**STATE OF HAWAII
DEPARTMENT OF TRANSPORTATION
AIRPORTS**

**ADDENDUM NO. 4
FOR
APRON LIGHT REPLACEMENT
AT
KAHULUI AIRPORT
KAHULUI, MAUI, HAWAII
AND
LANAI AIRPORT
LANAI CITY, LANAI, HAWAII
STATE PROJECT NO. AS1037-12R
AIP PROJECT NO. 3-15-0006-064-2025**

May 27, 2026

ELECTRICAL PLAN 5

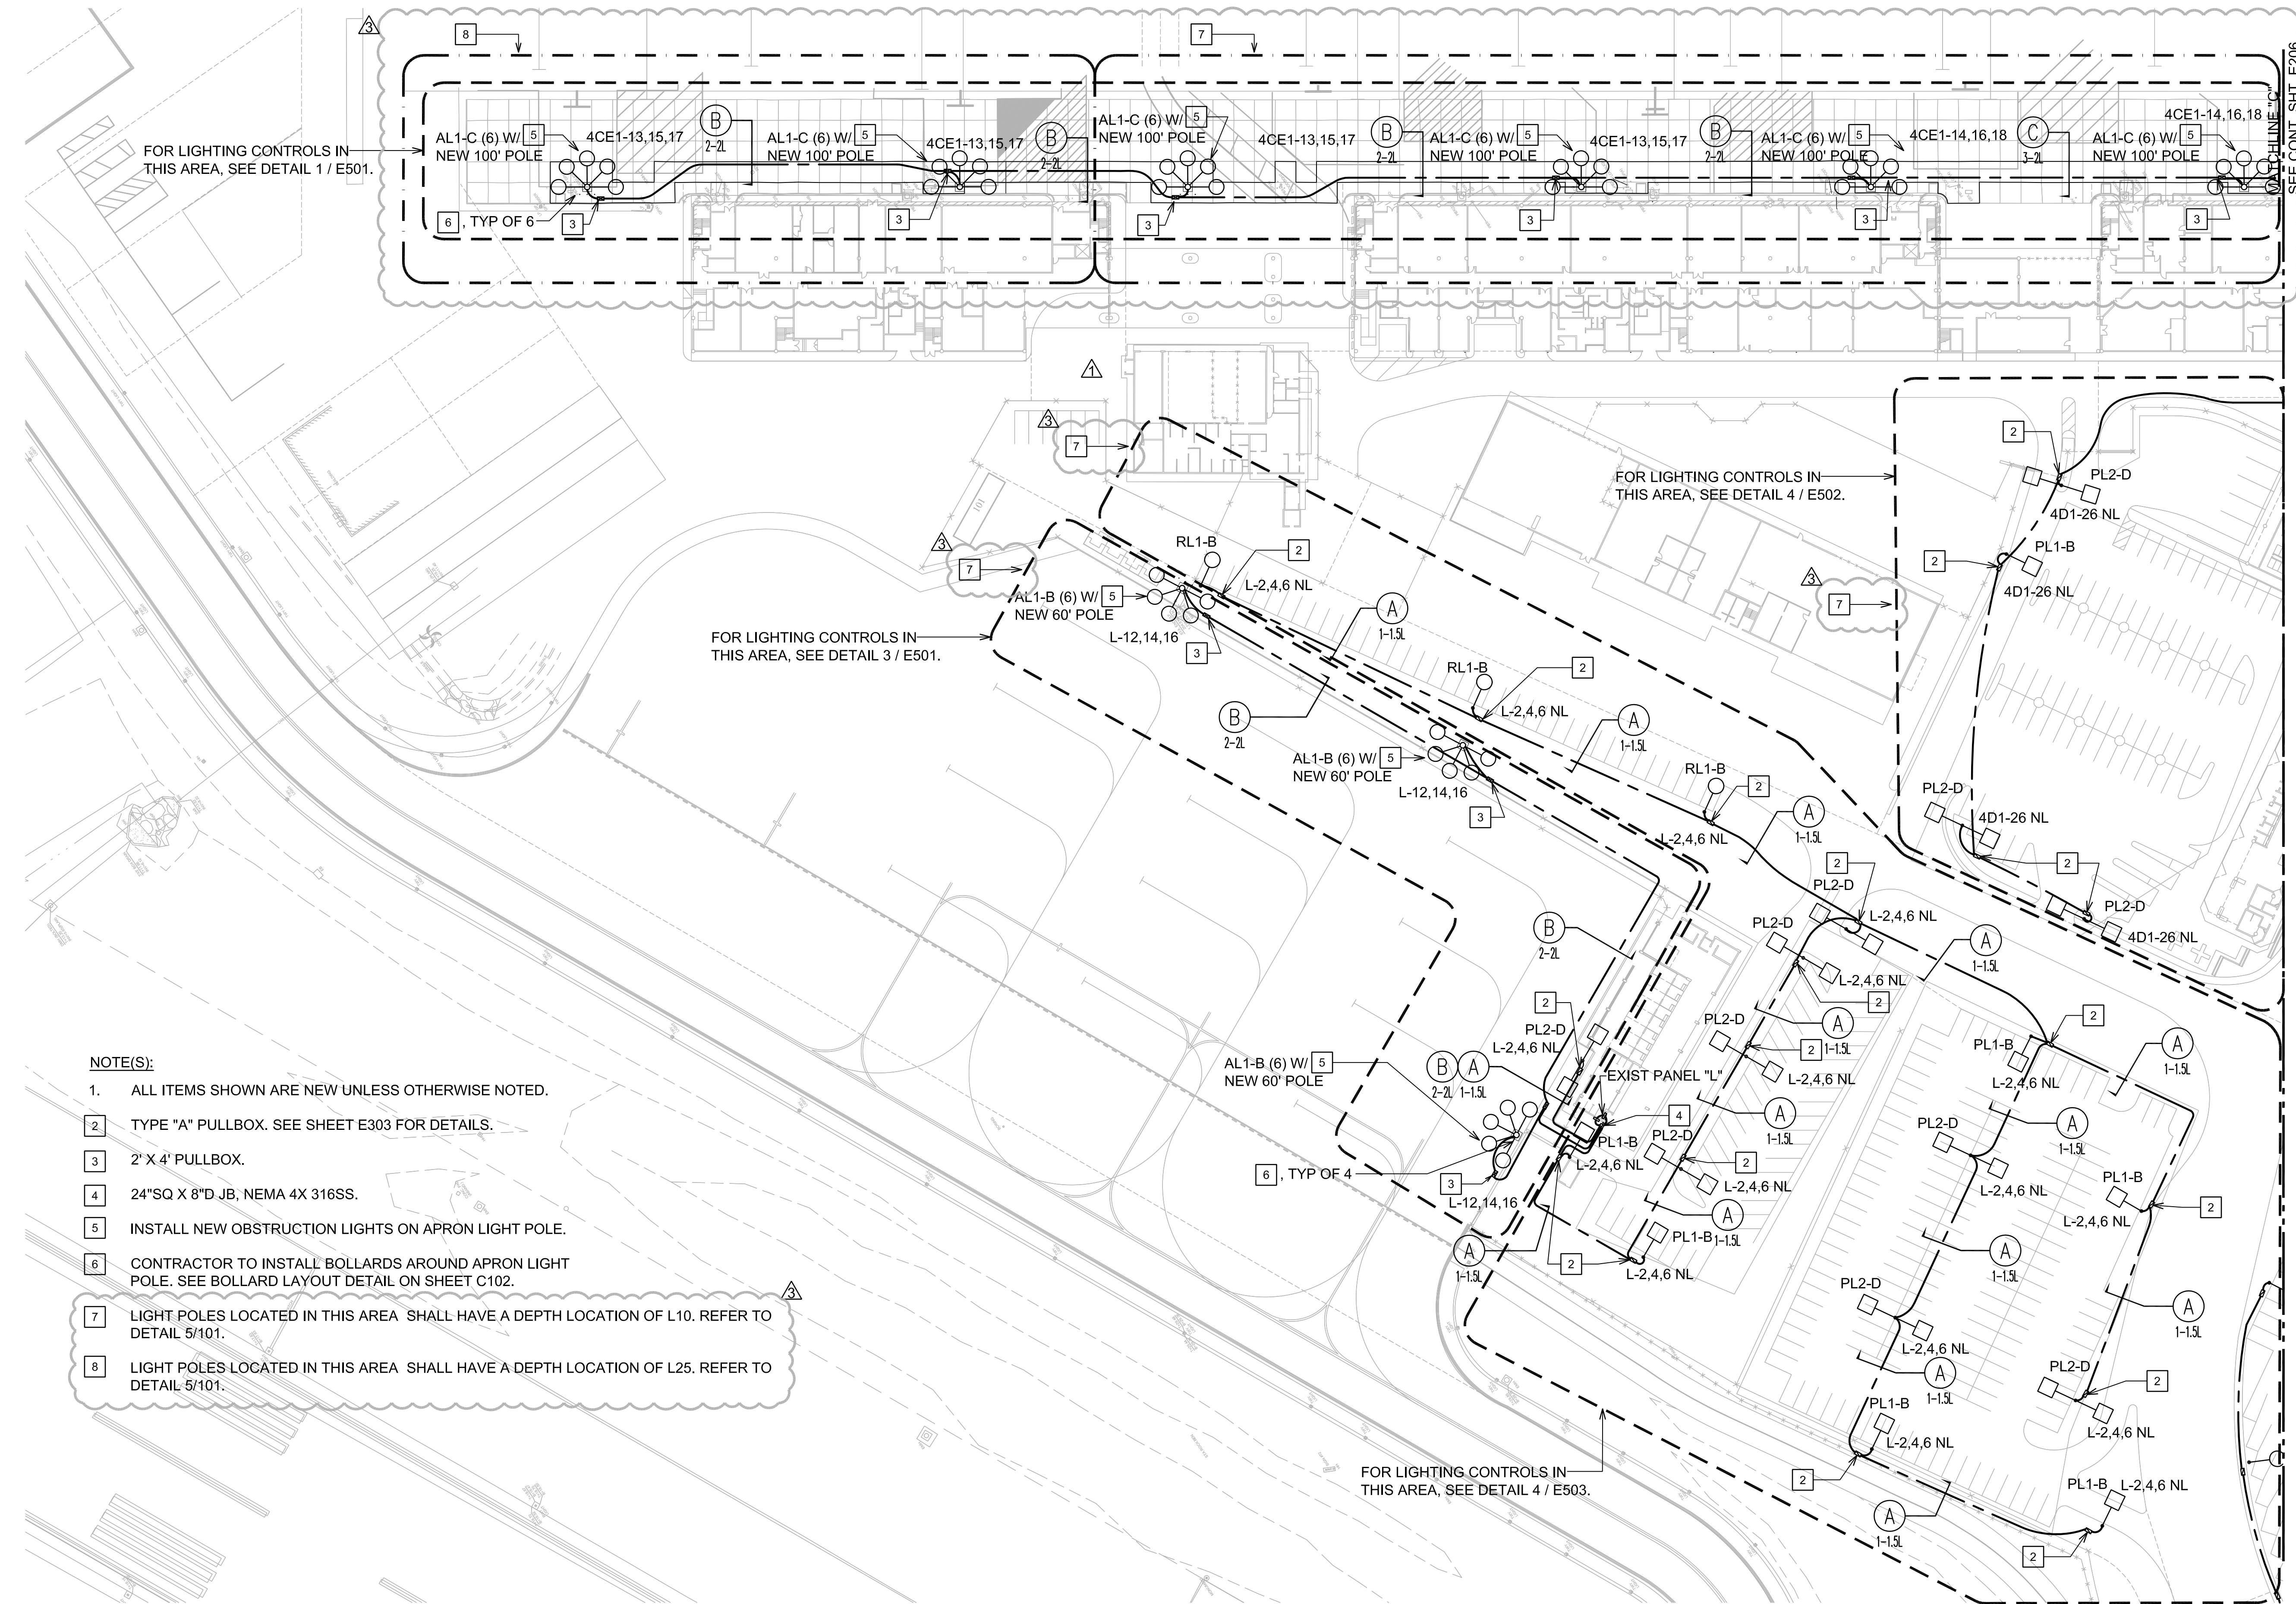
57. KAHULUI PLANS NOTE 5 ON THE DRAWING E205 STATES INSTALL NEW OBSTRUCTION LIGHTS ON THE APRON LIGHT POLE. ARE THEY ASKING FOR TWO OBSTRUCTION LIGHTS PER POLE?

Answer: Place 1 dual-head obstruction light at the top of each pole.

SHEET TITLE :
ELECTRICAL PLAN 6

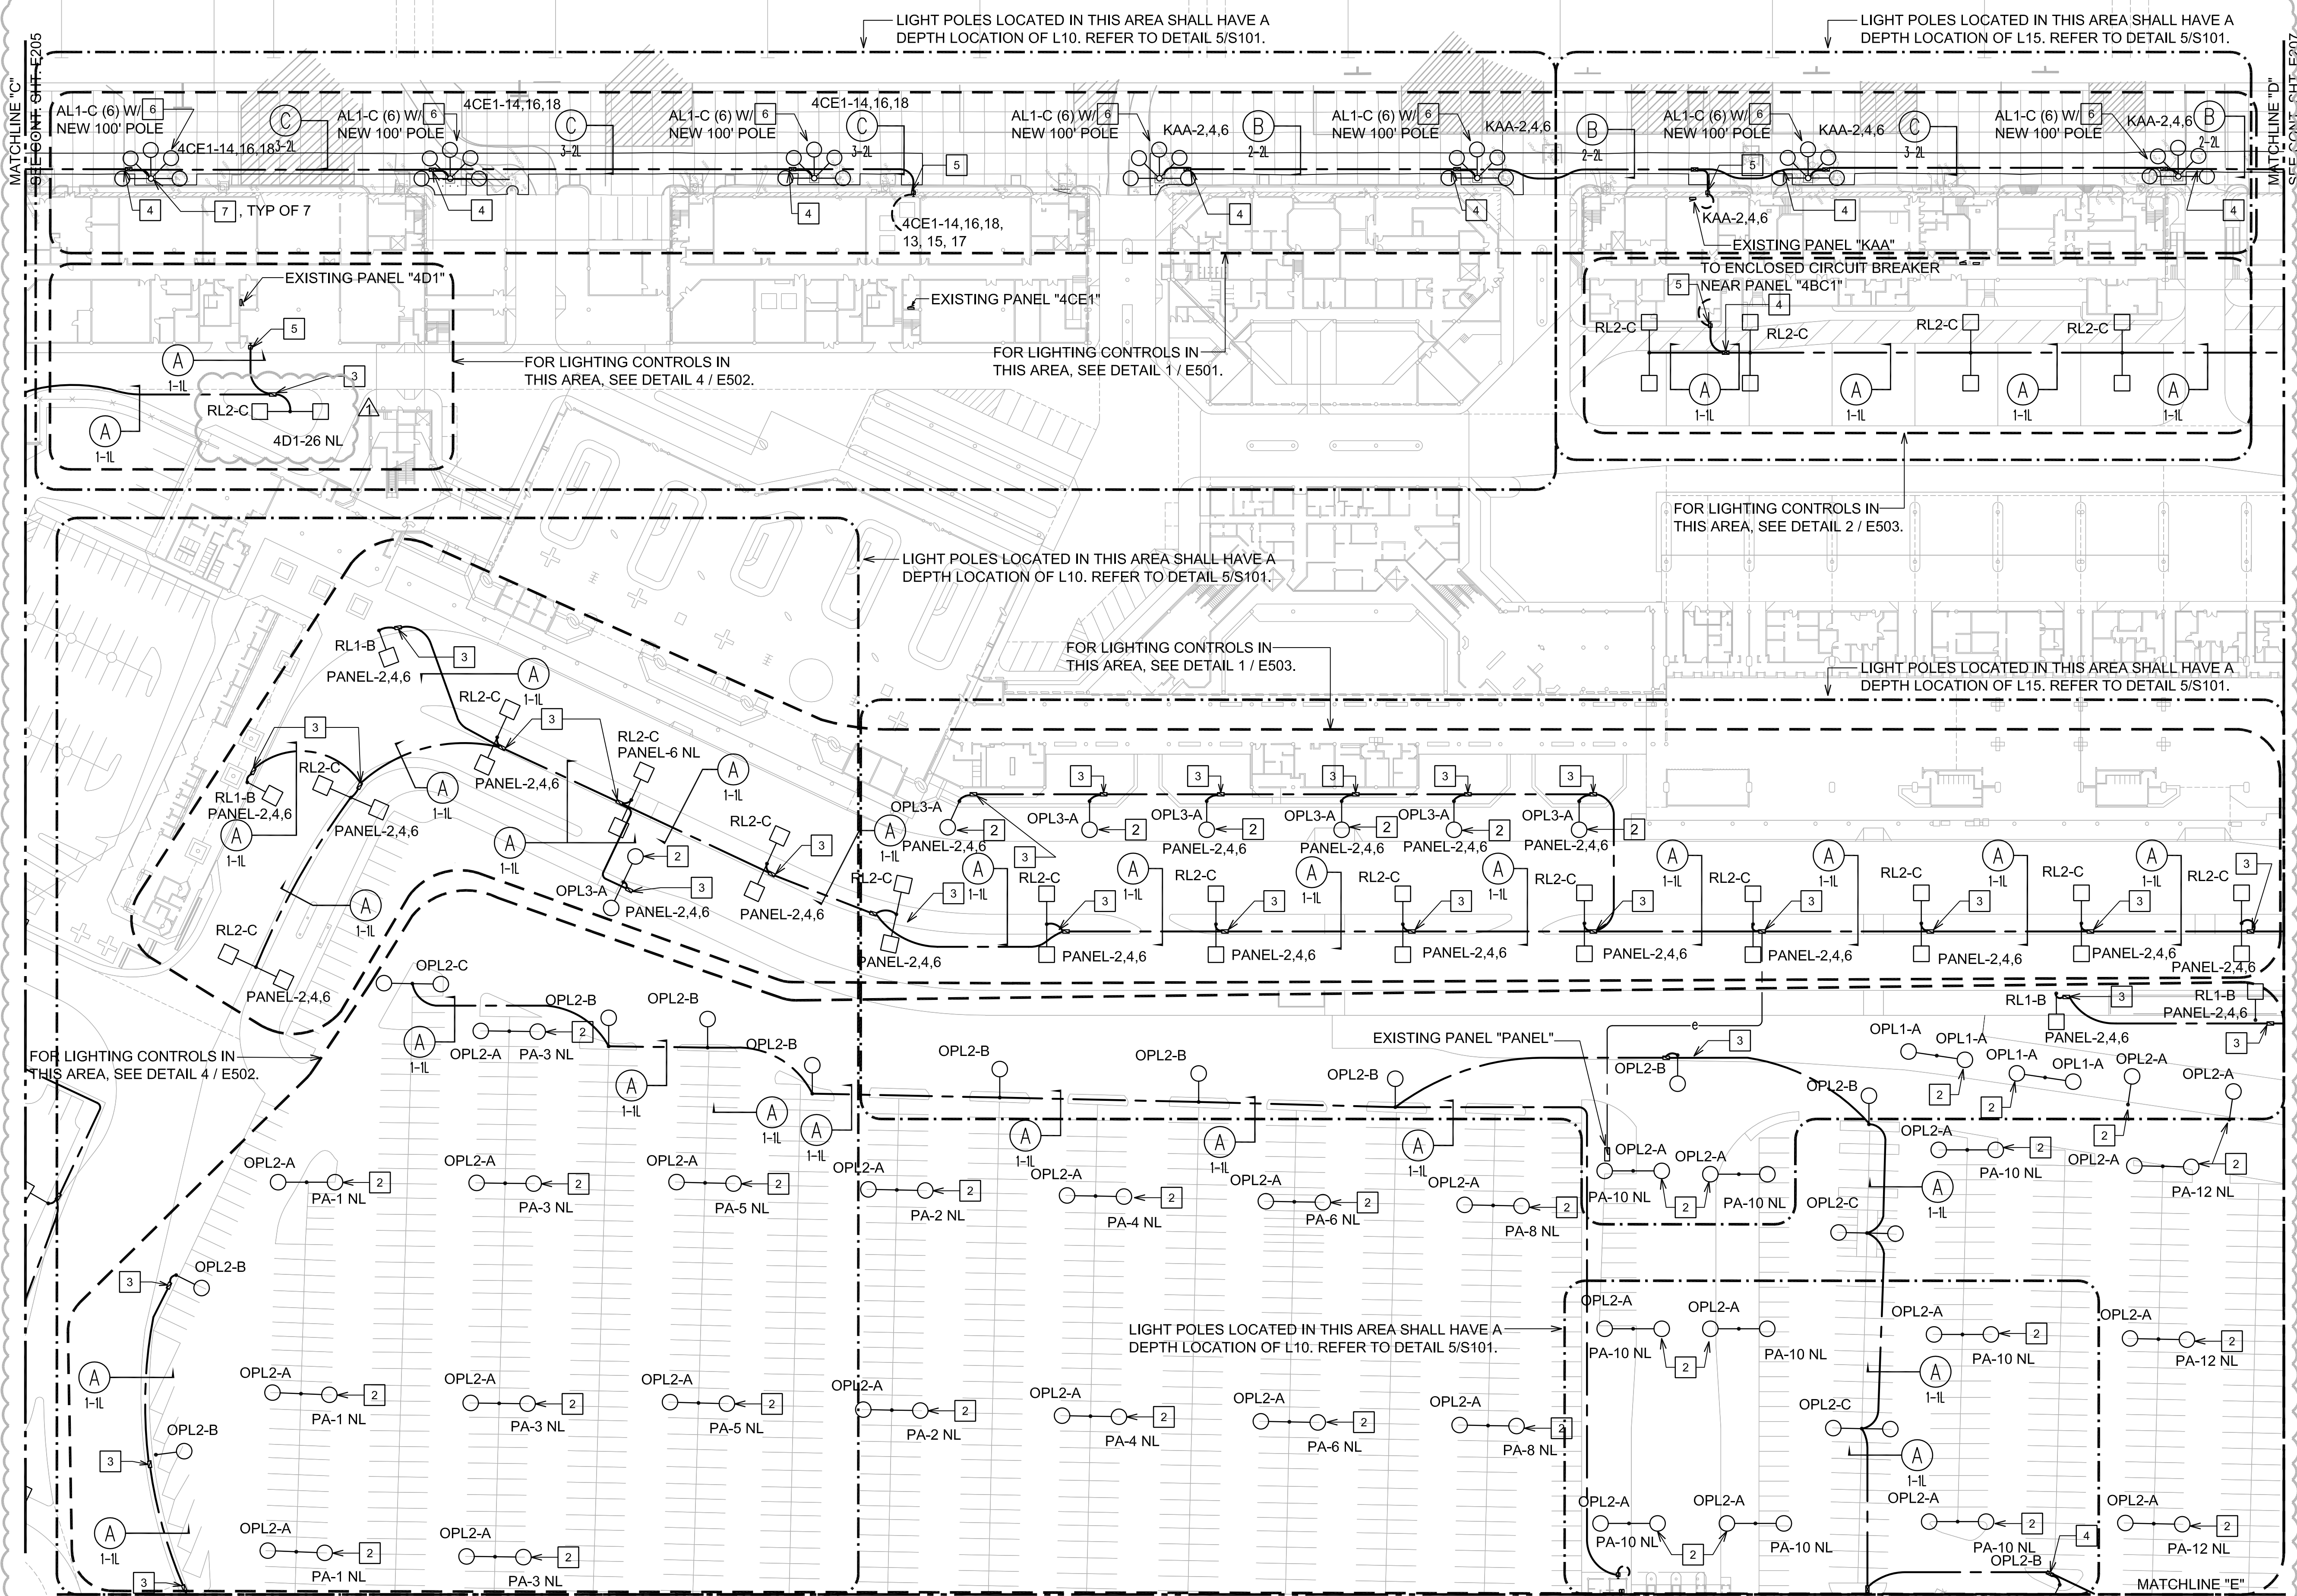
48. ON SHEET E206, IN THE LIGHTING CONTROL AREA OF DETAIL 1/E503, THERE IS A OPL3-B POLE ON THE LEFT SIDE OF THE MIDDLE AREA THAT HAS TWO LUMINAIRES ON THAT POLE. ON THE POLE AND FIXTURE SCHEDULE ON SHEET E311 THIS POLE ONLY HAS ONE LUMINAIRE ON IT. PLEASE CONFIRM THE CORRECT SPEC

Answer: The light fixture schedule and plan will be corrected in the upcoming addendum.

DATE :	DWG. NO.
AUGUST 2025	E207
SHEET :	
52 OF 75 SHEETS

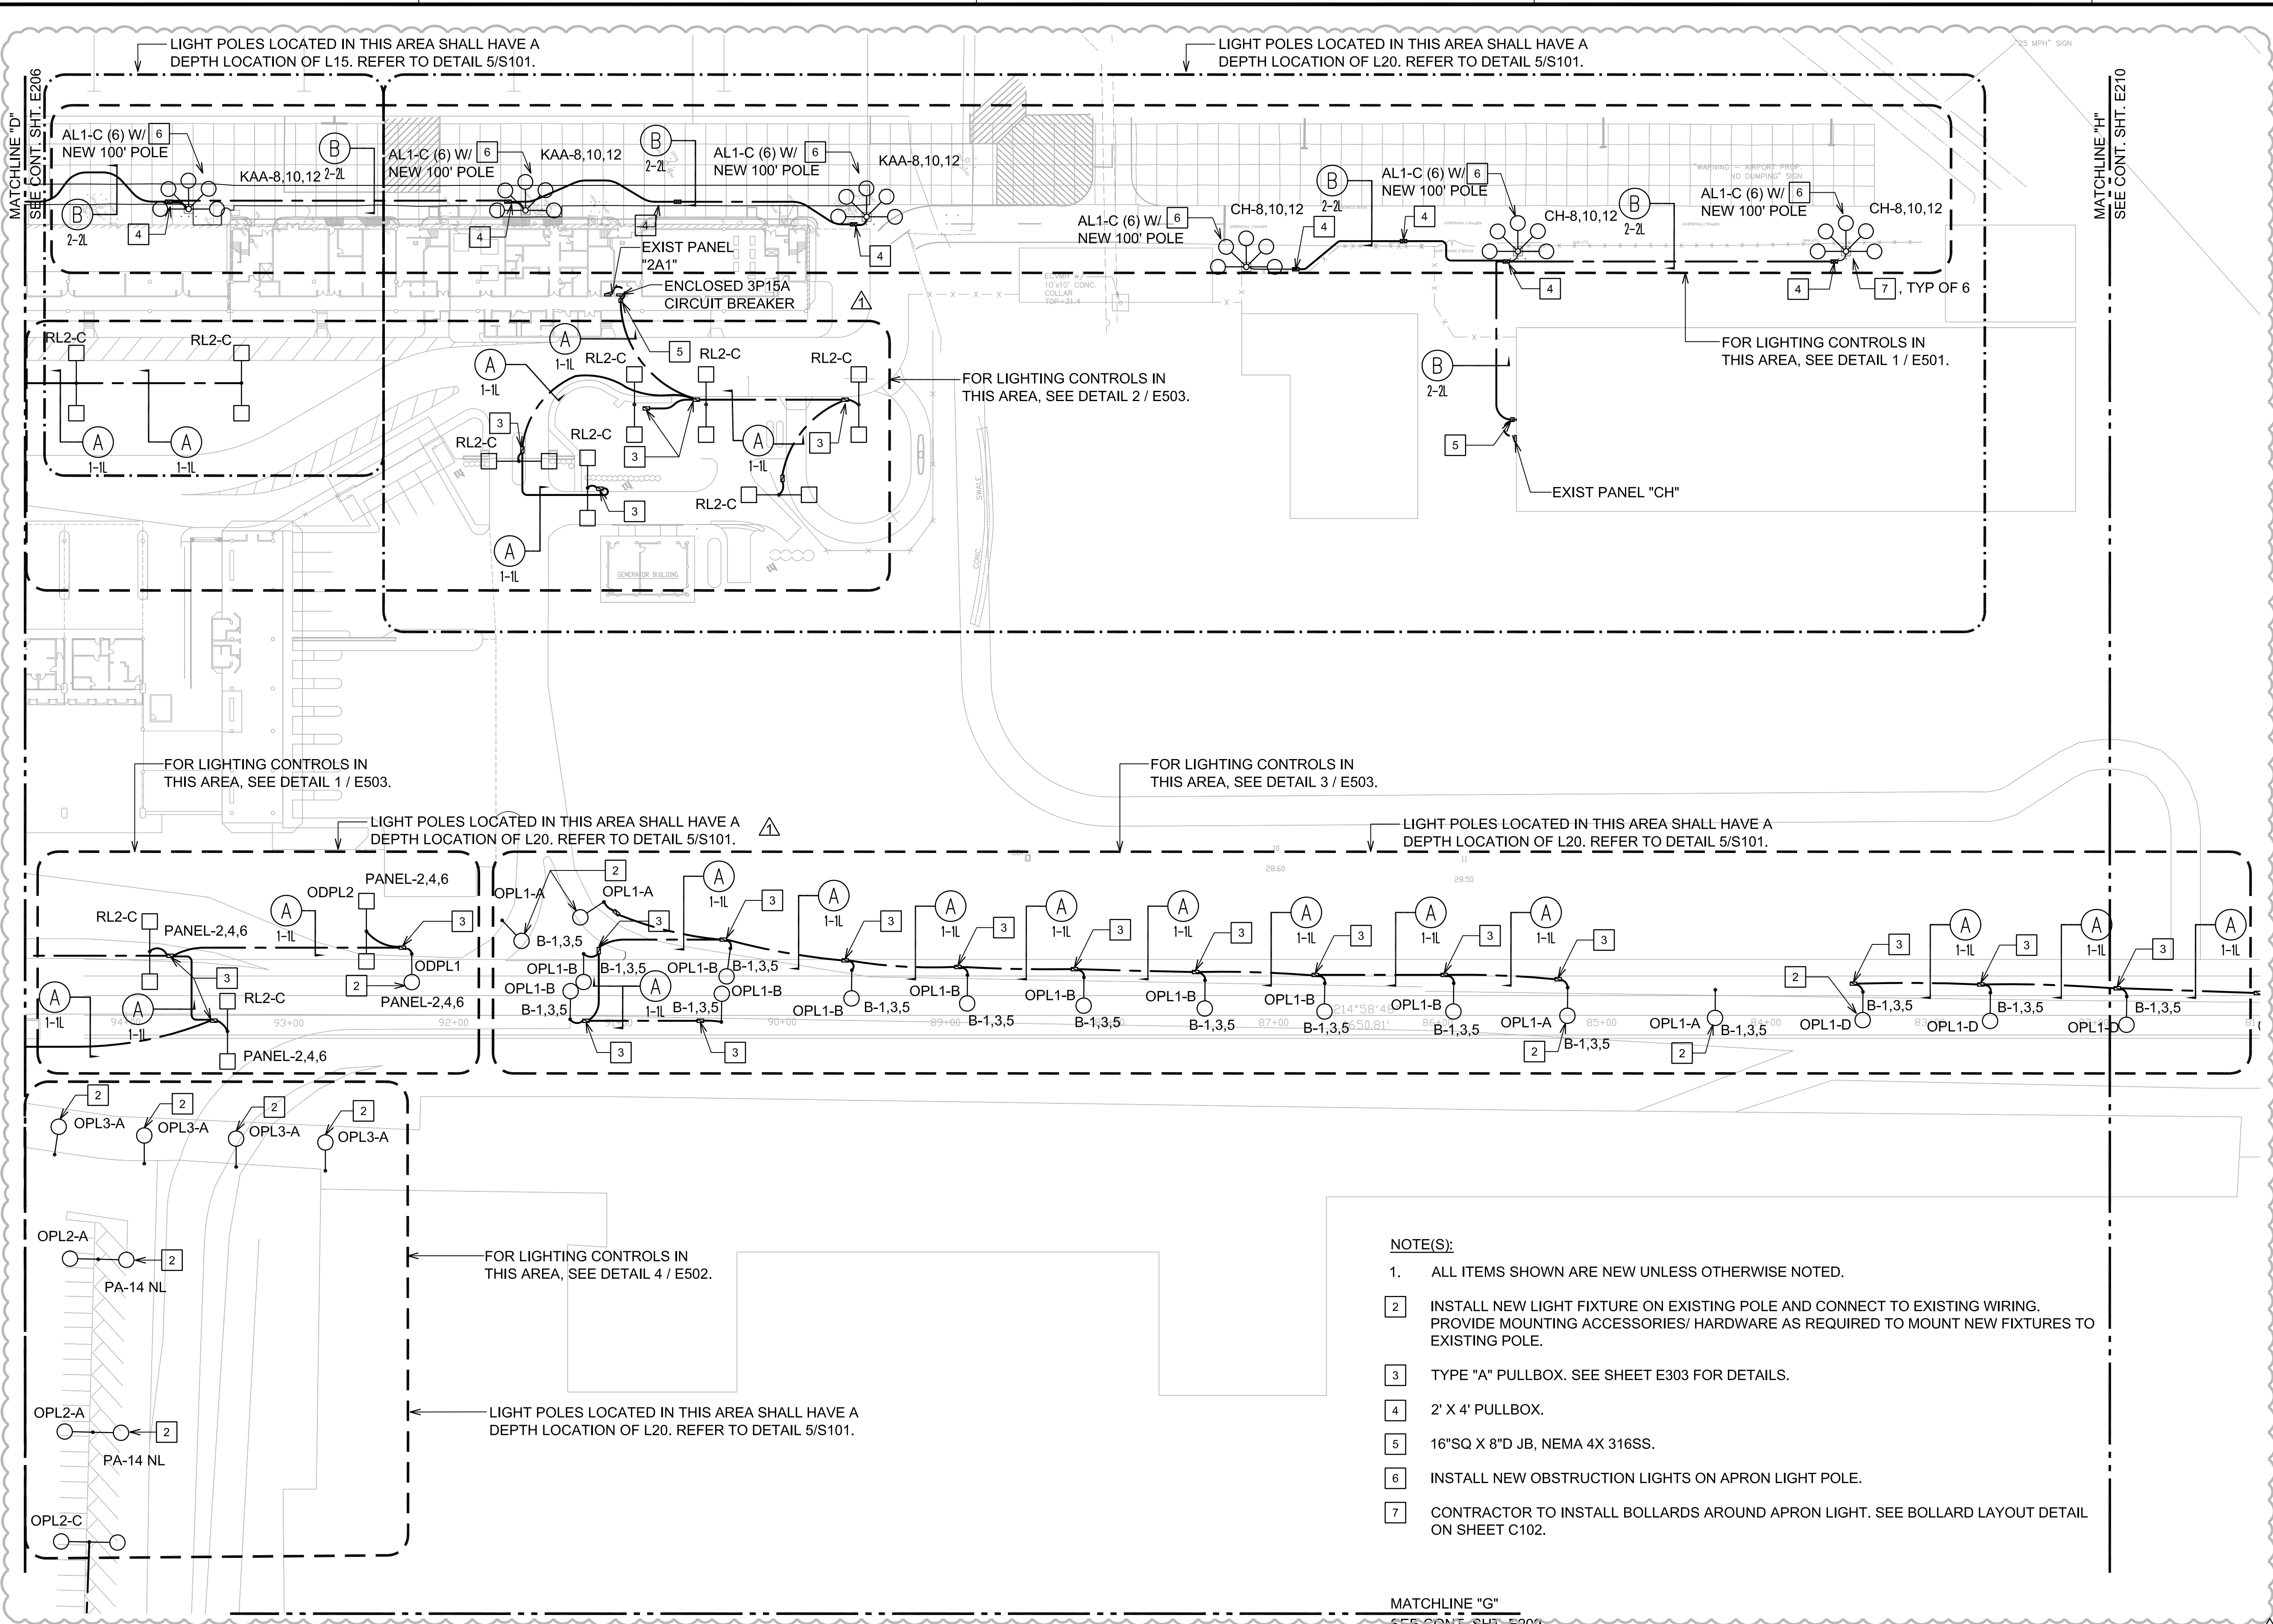
51. ON SHEET E207 THERE IS A LIGHT POLE AT THE BOTTOM OF THIS AREA OPL2-C THAT IS OUT OF PLACE WITH THE OTHER LIGHTING IN THIS AREA. IF YOU TURN TO SHEET E209 THE CONTINUATION OF THIS AREA THE FIXTURES ARE OPL2-A. DO WE KEEP THE OPL2-C FIXTURES OR CHANGE THEM OUT TO OPL2-A FIXTURES? ARE WE CHANGING ALL THE FIXTURES ON THESE POLES IN THIS AREA BOTH ON SHEET E207 AND E209?

Answer: Revised matchline. For the main parking lot, there is a mixture of reusing existing poles with new light fixtures as well as new poles with new light fixtures. Contractor will need to refer to the plans carefully to see which poles are which.
